FAA Response to SFO Roundtable

April 3, 2019

Federal Aviation
Administration

SIMULATION aircraft on existing SSTIK SID and potential SSTIK_ SID with May 1, 2017 track data

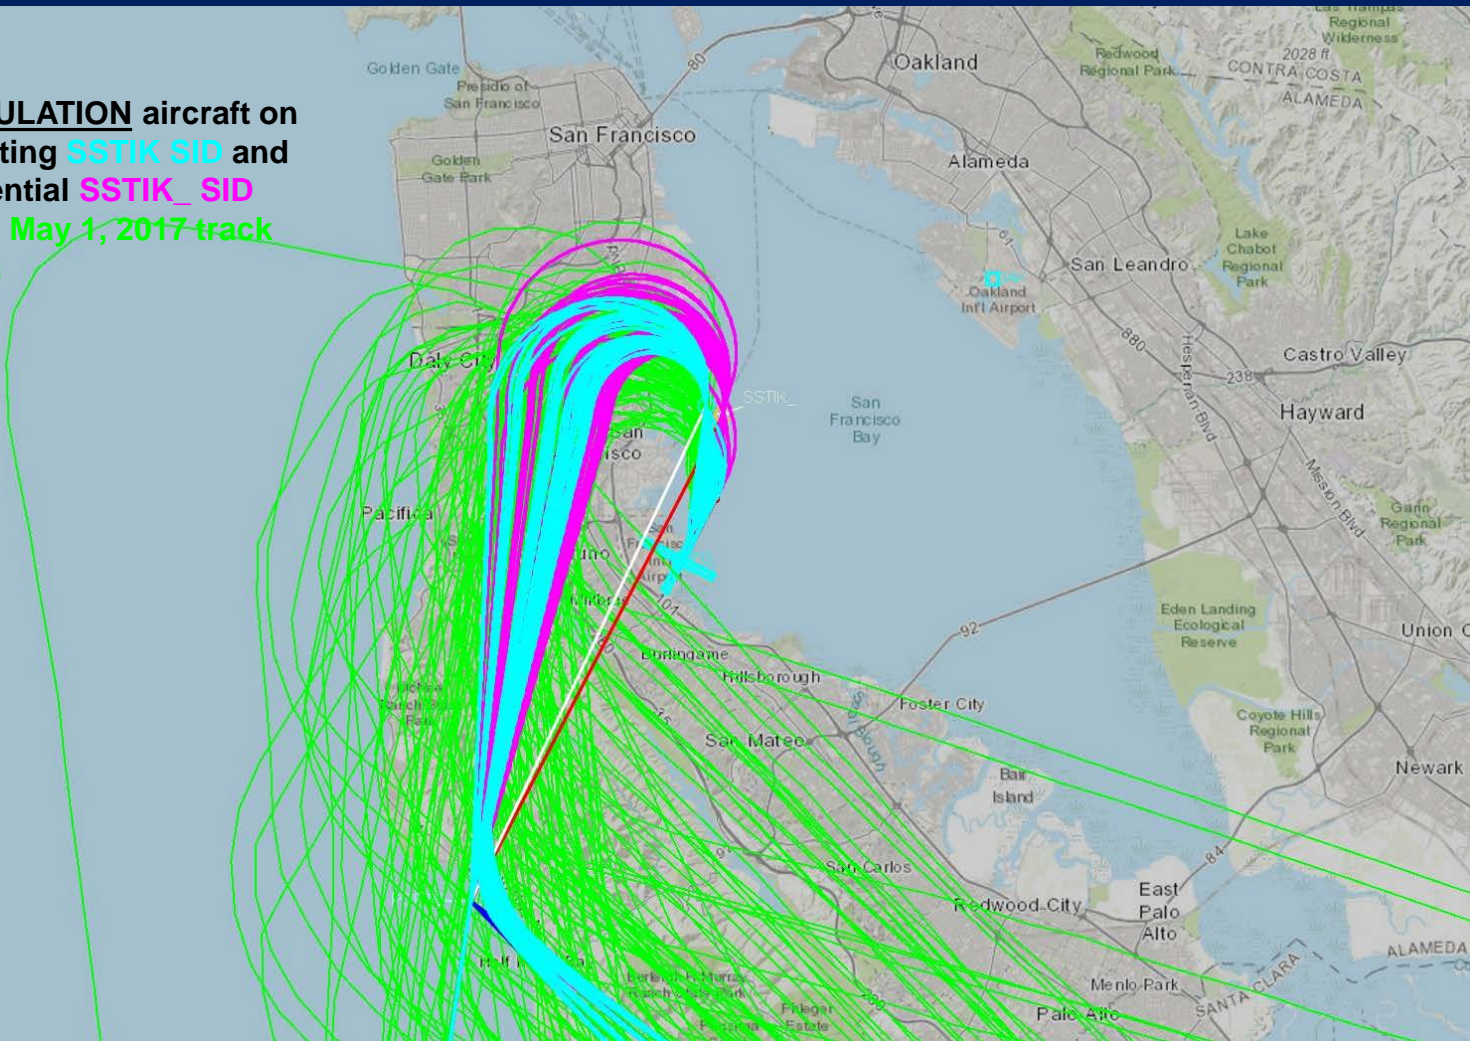
- Current Questions
 - Why is it being shelved?
 - What is the reasoning behind not being able to answer the previously submitted questions regarding this item?
- Previously Submitted Questions
 - Can the FAA overlay the proposed new SSTIK waypoint with the current SSTIK waypoint in the same image and provide both current and proposed SSTIK DPs in Google Earth KML files?
 - This will include the ground track for the procedure as it is today as well as the procedure as it would look with the new SSTIK waypoint. We request modeled flight track information for these two waypoints on the SSTIK procedure as well as the new charting date.
 - Please provide the design notes for the change in the SSTIK waypoint location.

Proposed SSTIK
waypoint move to
the ESE 0.44nm

NIITE/HUSSH SIDs – Steps Forward

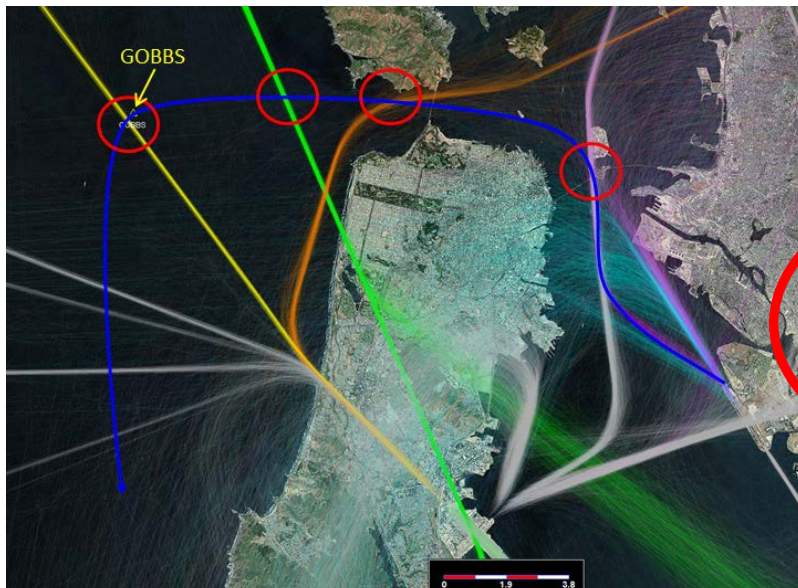
- Can the FAA please present these slides at the Roundtable’s Technical Working Group (TWG) meeting scheduled for March 7, 2019, and provide their explanation on the best way forward?

- After the SFO Roundtable has fully discussed, vetted, and formally agreed upon the recommendation, it should be assigned to a “Technical Working Group”
- The Technical Working Group should include individuals from the OAK Noise Forum, and/or OAK Airport, as the recommendation will affect both SFO and OAK airports
- The SFO Roundtable Chairperson should request FAA participation through the AWP Regional Administrator’s Office

- **FAA has long recognized that the SFO RT/Select Committee recommendation regarding NIITE/HUSSH southbound departures is one of the top priorities.**
- **We have done a preliminary look at data and constraints, and are ready to bring our subject matter experts to discuss a way forward in technical working meetings.**
- **For the FAA to participate and ensure that the meetings are efficient and productive, both SFO and OAK airports, as well as representative airlines that fly in and out of these airports must participate in the technical meetings.**
